DEVELOPMENT REVIEW APPLICATION

For Office Use Only		
STAFF CONTACT <i>Jennifer Arnold</i>	PROJECT NO(S). <i>DR-18-09</i>	
NON-REFUNDABLE FEE(S) <i>2,100.00</i>	REFUNDABLE DEPOSIT(S) <i>-</i>	TOTAL <i>2,100.00</i>

Site Location/Address: <i>1748 WILLAMETTE FALLS DRIVE WEST LINN, OR 97068</i>	Assessor's Map No.: <i>31E02BA</i>
	Tax Lot(s): <i>1902</i>
	Total Land Area: <i>5,153 sq ft (0.12 AC)</i>

Brief Description of Proposal:
APPLICANT REQUESTS ALTERATIONS TO HIS APPROVED DESIGN REVIEW APPLICATION (DR 17-01). REQUEST TO REVISE WINDOWS ON WEST ELEVATION & CHANGE WOOD SIDING TO FIBER CEMENT.

WEST ELEVATION - APPROVED SUBMITTAL

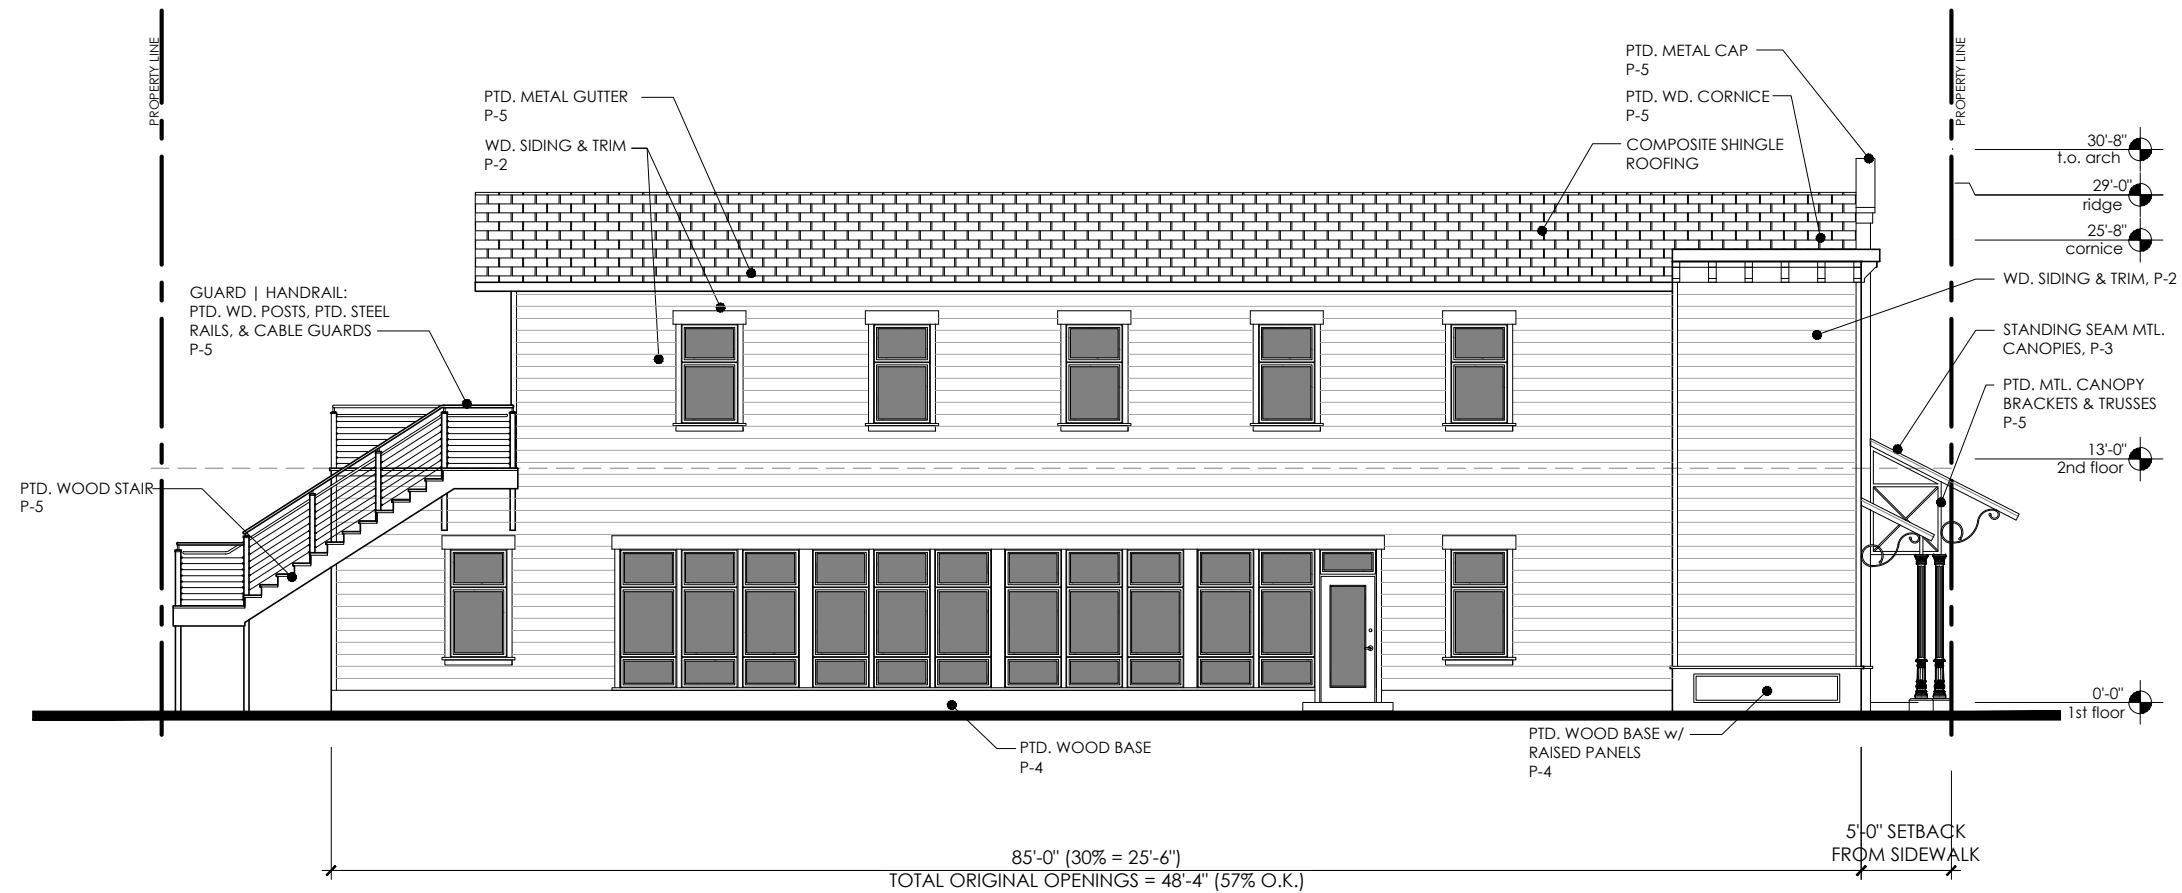
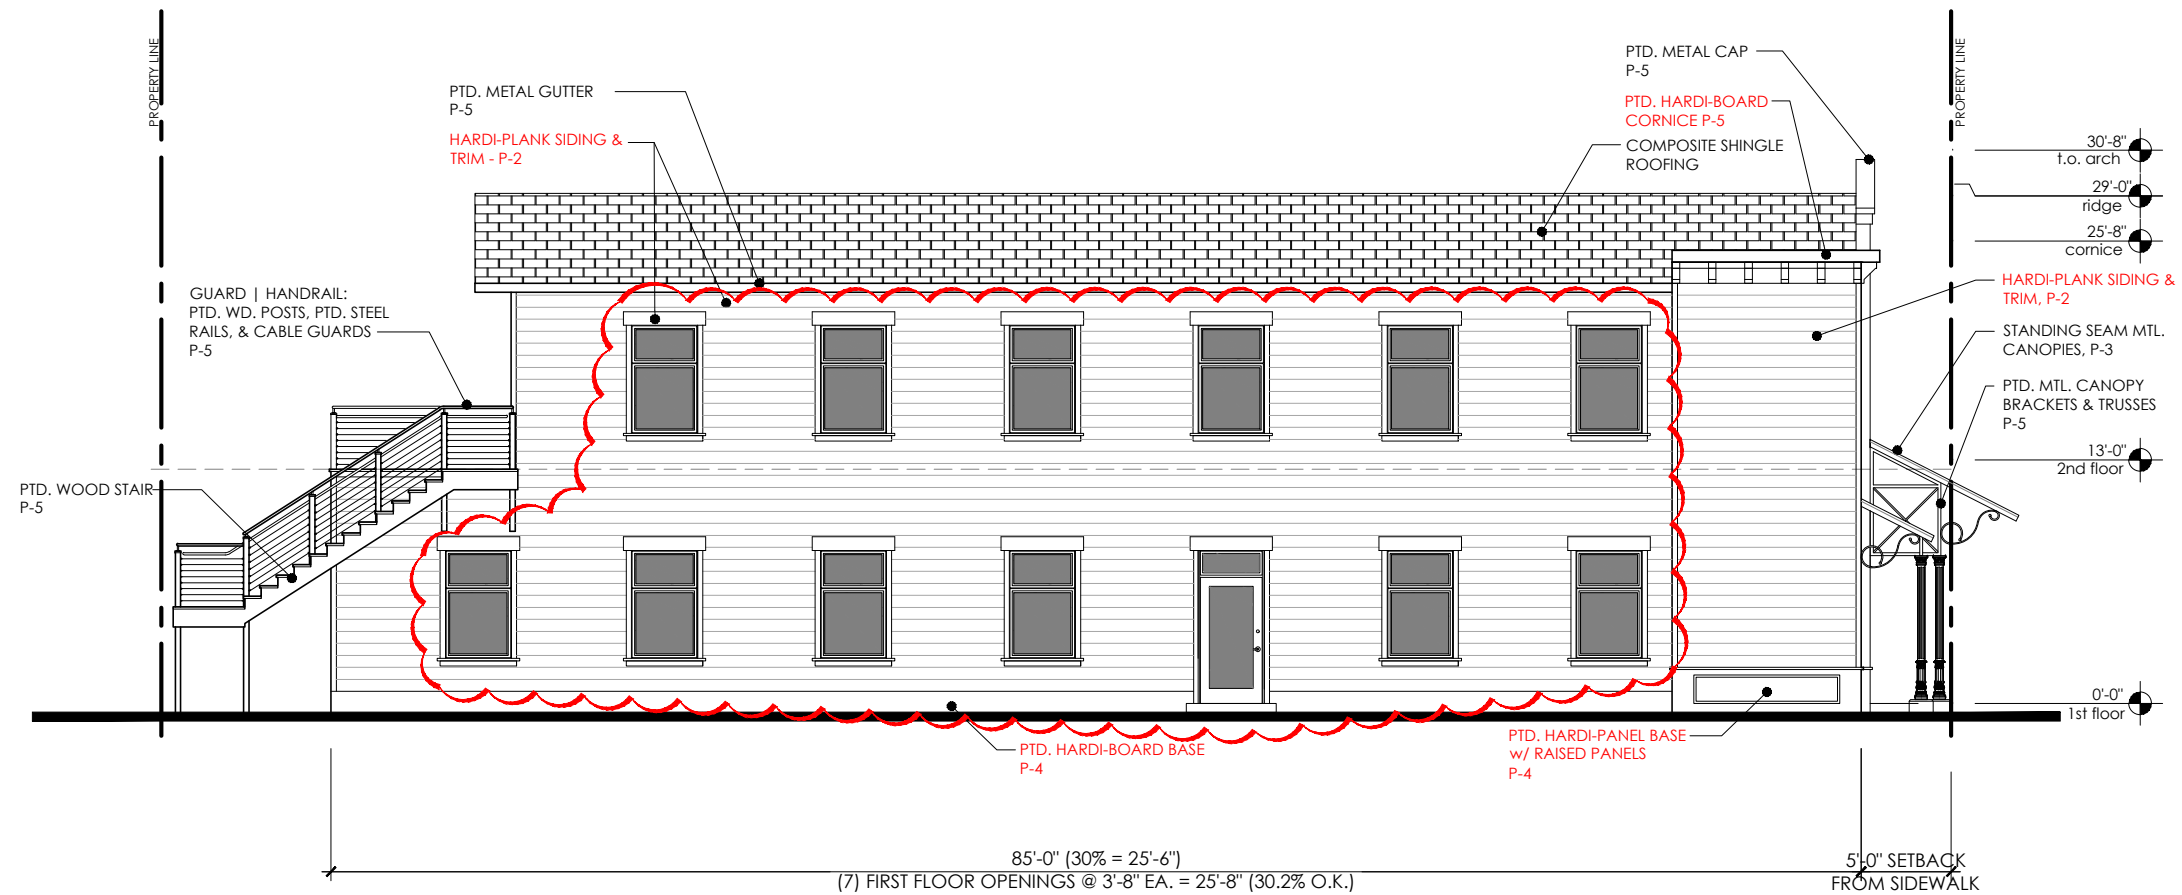
PROPOSED REVISION (TYPE 1 REVIEW): Per this proposed alteration, the windows on the west elevation will be revised from a single large opening flanked by 2 smaller windows to six evenly spaced windows and a glass man door. The new layout will result in 25'-8" of opening in an 85'-0" of elevation for a total of 30.2%. With this proposed change, the percentage of opening requirement for the side elevation is still met.

WEST ELEVATION - PROPOSED REVISED HRB SUBMITTAL
